Subject: Our Lady of Guadalupe Delhi Rectory at 542 East Central Avenue, DP No. 2018-06R

(Master ID No. 2018-141605), ER No. 2018-24 (plans dated 05-08-2019, received 6-26-

December 3, 2019

Subject: Our Lady of Guadalupe Delhi Rectory at 542 East Central Avenue, DP No. 2018-

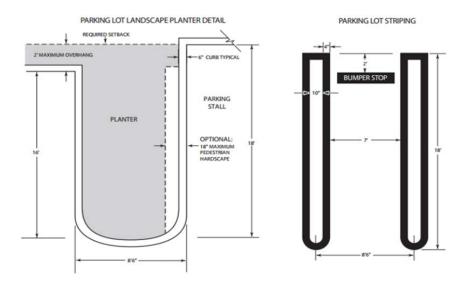
4) Redesign the parking lot layout to comply with standard striping design as shown below. Additionally, extend the adjacent landscape planter or curb for two feet at the head of the parking stalls in lieu of installing wheel/bumper stops (see **Diagram Below**).
